**REGULAR MEETING OF THE
VINEYARD PLANNING COMMISSION,
Vineyard City Hall, 125 S Main St., Vineyard, Utah
Wednesday, October 2, 2019 at 6:00 p.m.**

5.1 Waters Edge Clubhouse 2

Date: October 2, 2019
From: Elizabeth Hart, Planner
To: Planning Commission
Item: Waters Edge Clubhouse 2
Address: 213 N. Vineyard Road
Applicant: Bronson Tatton, Flagship Homes
Owner: Flagship Homes

OVERALL
site plan

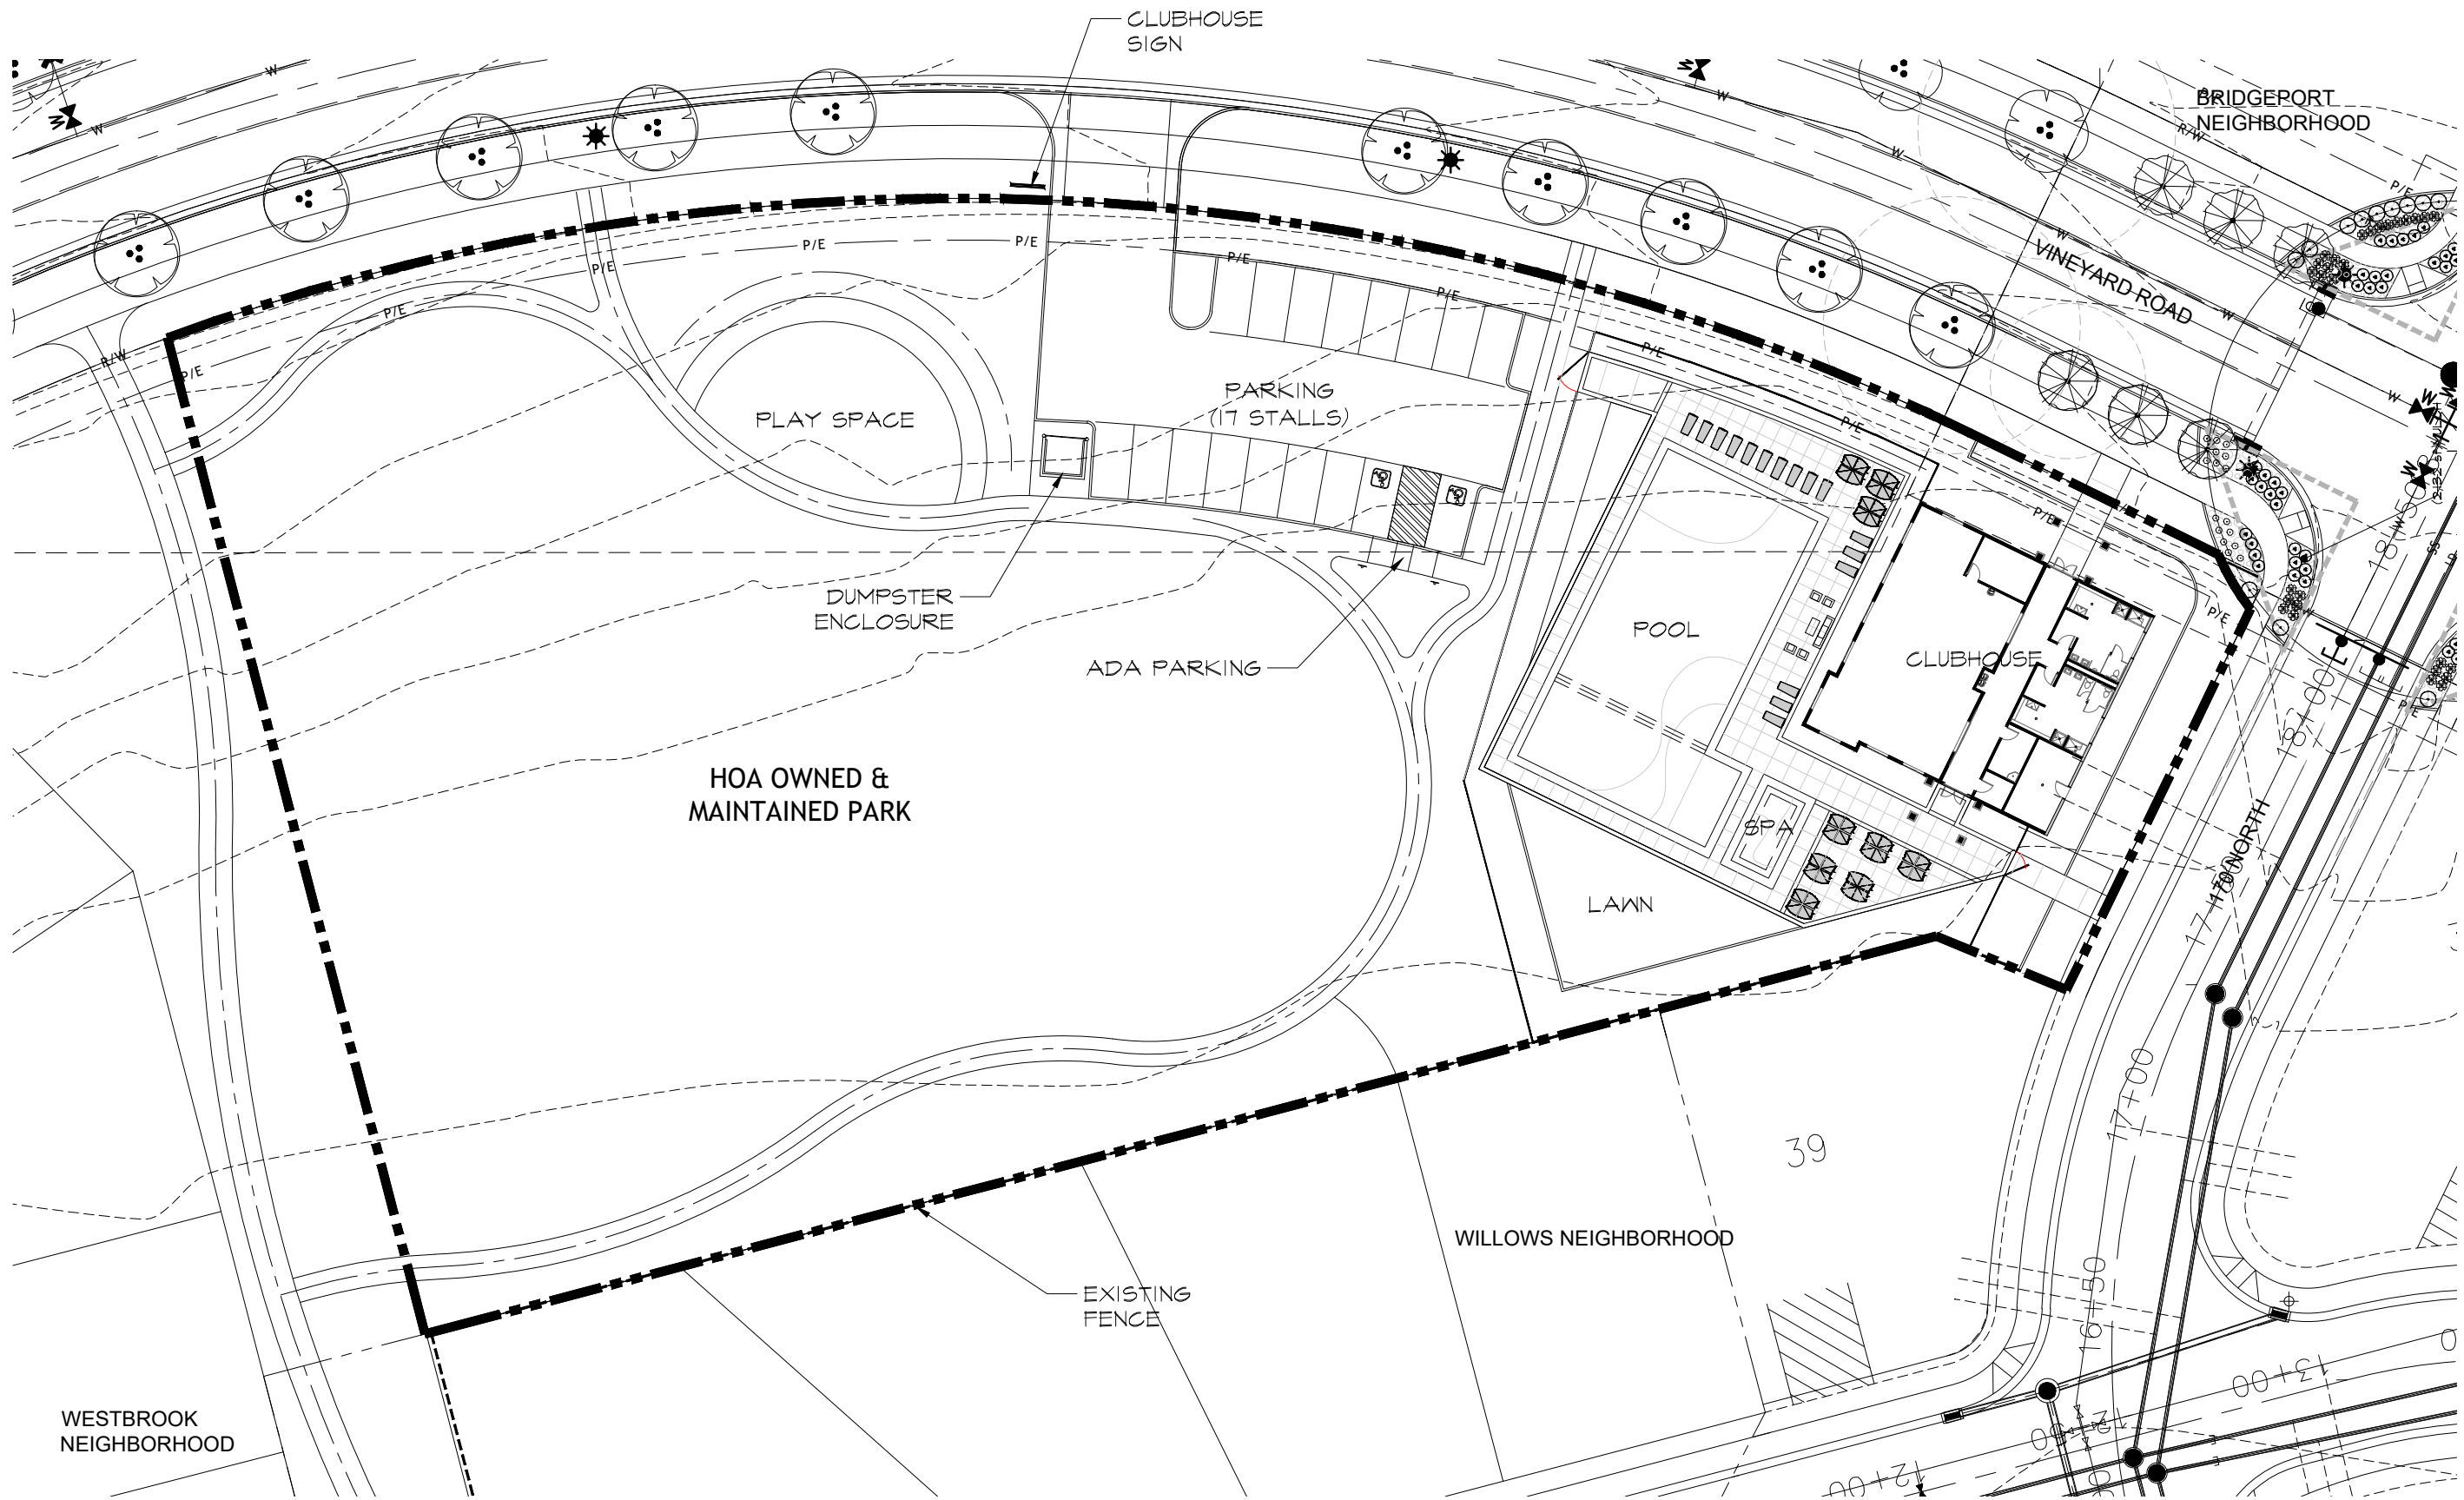
15.38.030.1.f. Parking Aisle Dimensions	Angle	1way Aisle	2way Aisle	Aisle is 24 feet in width.	☒ Yes ☐ No ☐ N/A
	90 deg.	24 ft	24 ft		
15.38.030.1.n. Screening	All off-street parking lots of 4 or more spaces shall be screened from the street view and adjacent residential districts by a landscaped berm, decorative wall, vertical landscaping, or combination there-of at 3 feet high, as measured at finished grade adjacent to the parking area to be screened. All walls or berms shall be installed a minimum of 2.5 feet back from the edge of the parking stall.			Additional shrubs in front the parking stalls along Vineyard Road are required. Staff has added a condition.	☐ Yes ☒ No ☐ N/A

15.38.030.1.o.ii.	Parking areas should be buffered from adjacent residential property and screened from streets so automobiles are not visible			More landscaping is required along Vineyard Road. Staff has added a condition.	☐ Yes ☒ No ☐ N/A

VZC Chapter 15.38 Parking and Loading Requirements			
Category	Standard	Staff Comments	Compliance
	below the average headlight height. Screen methods may include landscaped berms, low walls, and hedges		
Bicycle Parking	Minimum of 3 or 10% of the required vehicular parking.	Required to have a minimum of 3 bicycle parking facilities that meet the standards in the code. Staff has added a condition.	☐ Yes ☒ No ☐ N/A

- 1) Additional shrubbery is required in front of the parking stalls facing Vineyard Road
- 2) All plantings shall meet the minimum size requirements for installation. Deciduous trees shall be a minimum 2-inch caliper in size. All evergreen trees shall be a minimum of 6 feet in height. All shrubs shall be a minimum of 5 gallon in size.
- 3) The applicant is required to work with the Engineering Department on the Detention Pond.
- 4) A minimum of three (3) bicycle parking facilities are required to be installed and meet the requirements found in the Vineyard Zoning Code Chapter 15.38 Parking and Loading Requirements.

OVERALL
landscape plan

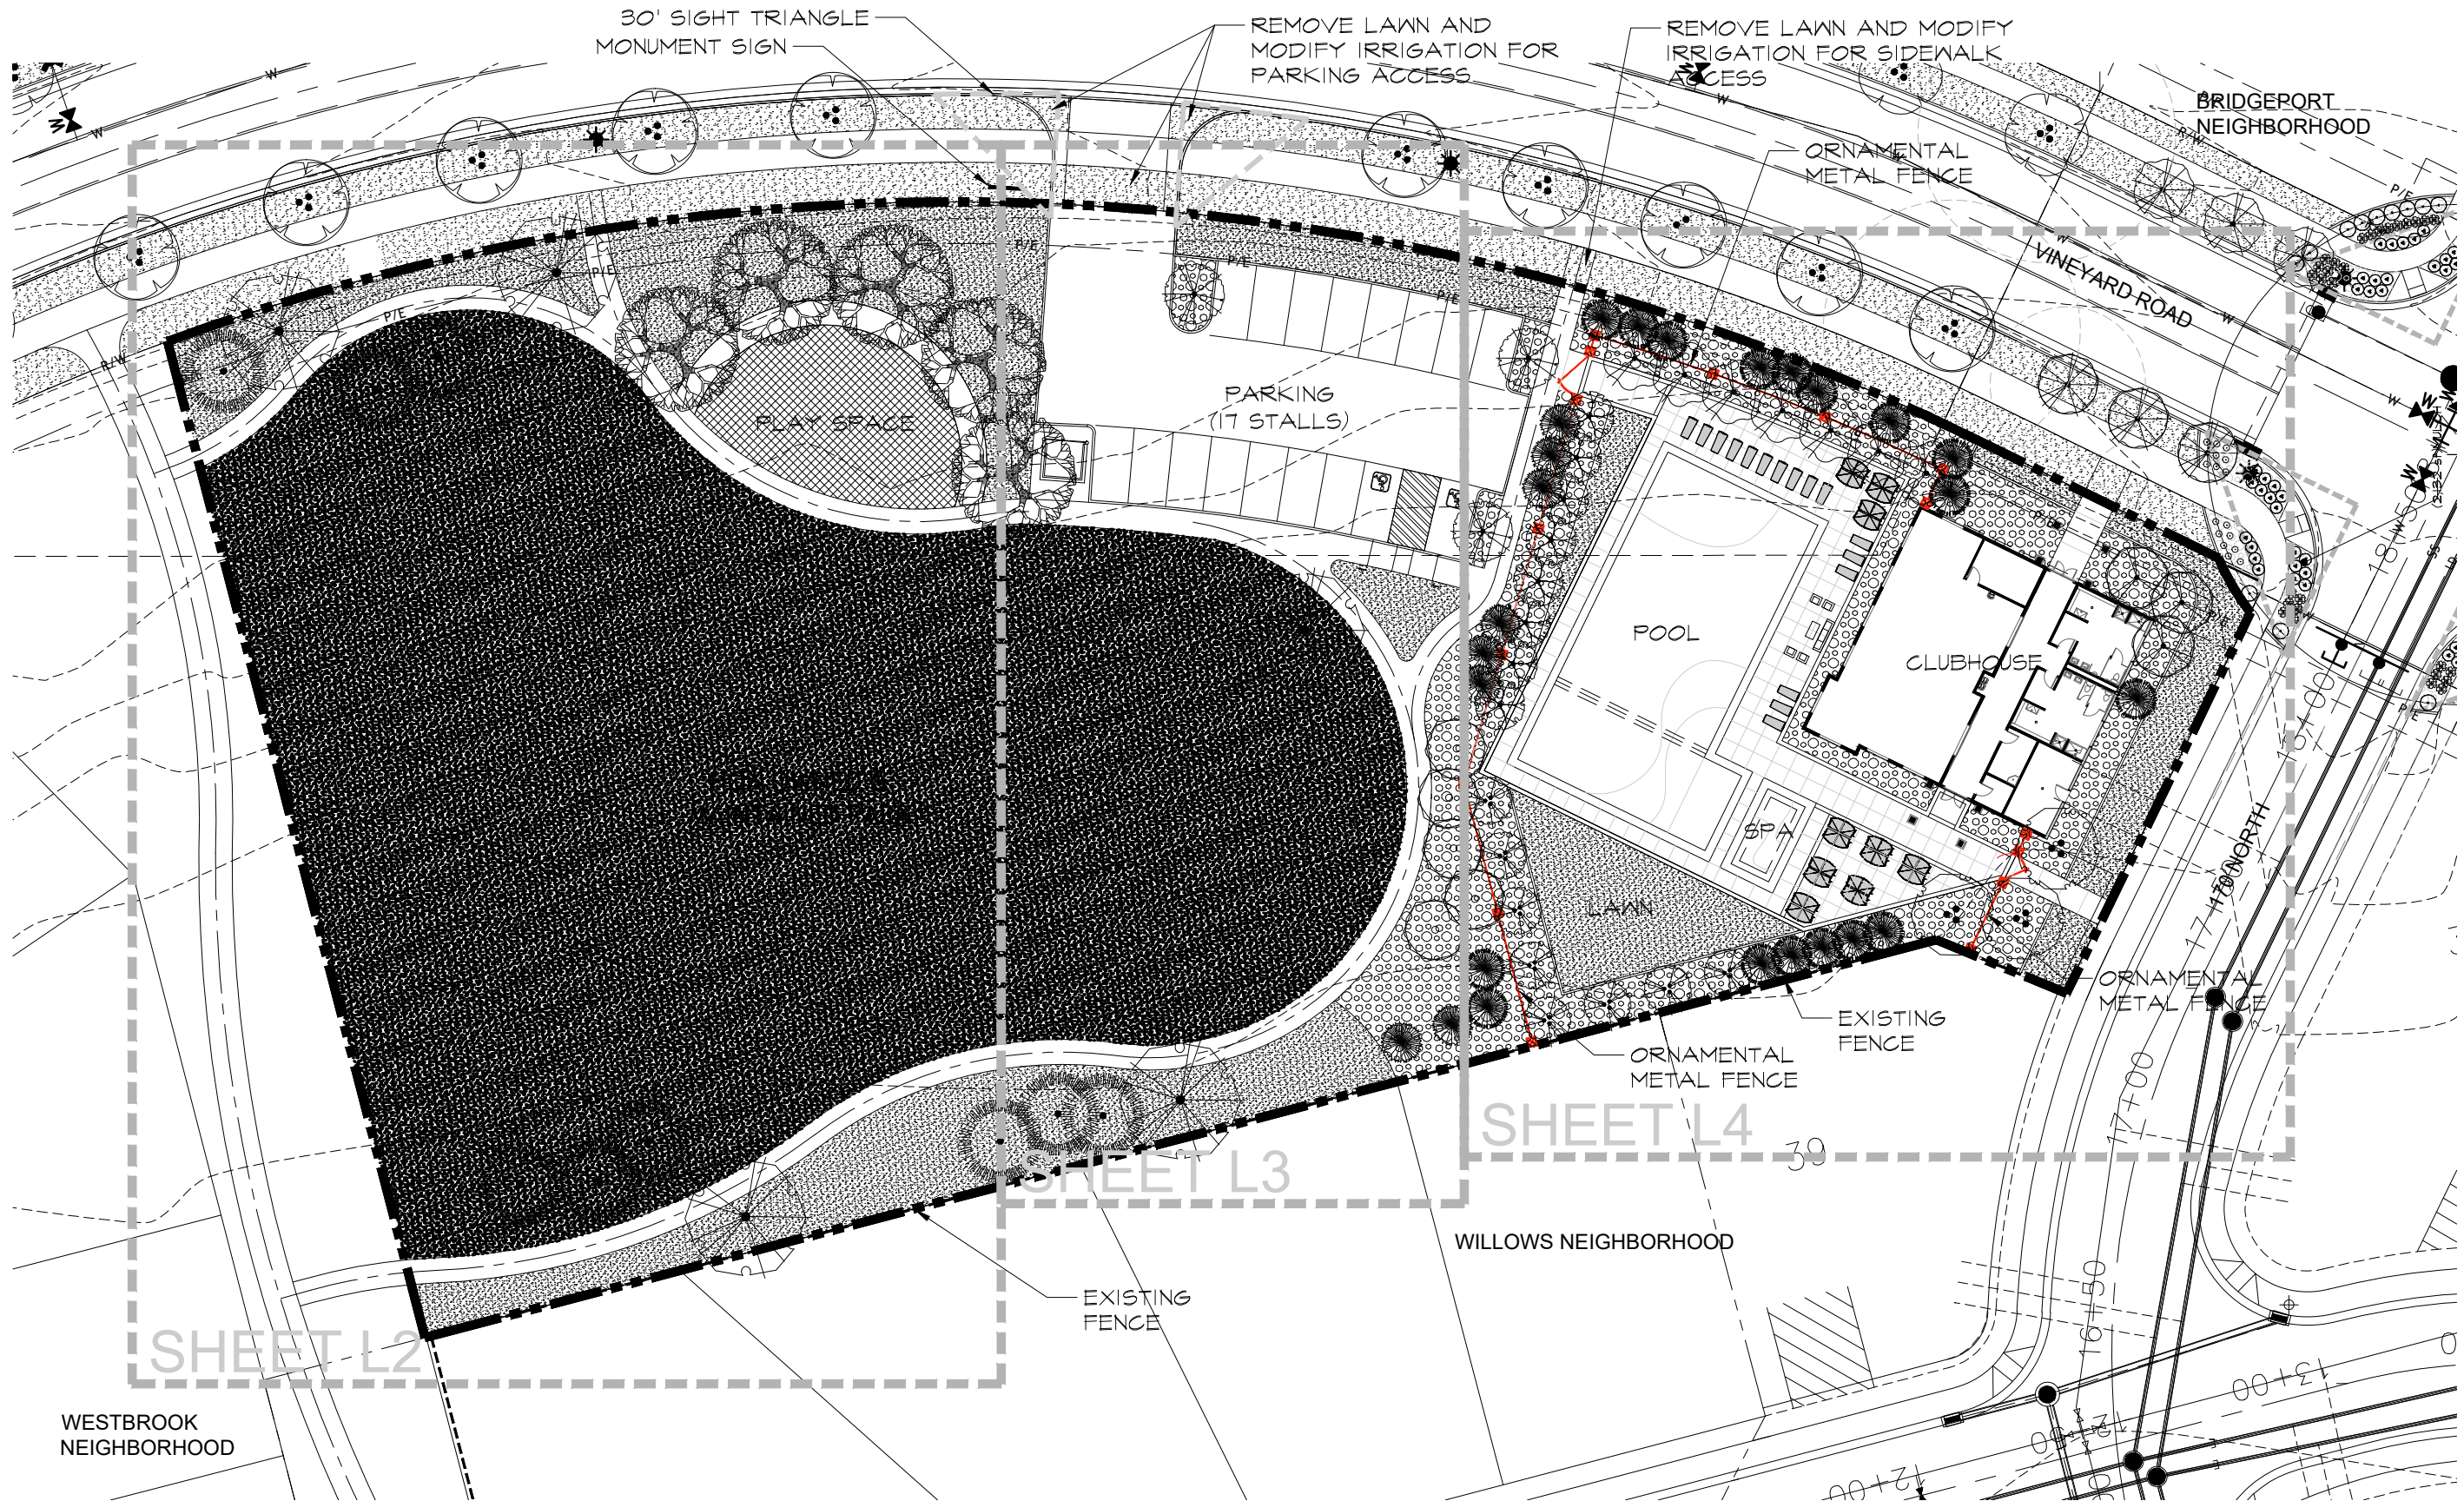
VZC Chapter 15.40 Landscaping			
Category	Standard	Staff Comments	Compliance
15.40.080.1.b. Minimum Size of Plantings	Unless otherwise specified herein, all required deciduous trees shall be a minimum of 2-inch caliper in size. All evergreen trees shall be a minimum of 6 feet in height. All shrubs shall be a minimum of 5 gallon in size.	All plantings shall meet the minimum requirements per code. Staff has added condition and will be checking this at the time of inspection.	☐ Yes ☒ No ☐ N/A

VZC Chapter 15.40 Landscaping			
Category	Standard	Staff Comments	Compliance
		on with the Engineering and Public Works department. There were concerns about the proposed detention pond being a nesting ground for mosquitoes. Staff has expressed these concerns with the applicant and the applicant is working with staff find other possible solutions.

15.40.080.6.c. Street Frontages	The landscape setback identified above shall be established and maintained along all street frontages between any perimeter wall,	Staff is requiring more shrubbery for a buffer along the parking lot facing Vineyard Road.	☒ Yes ☐ No ☐ N/A
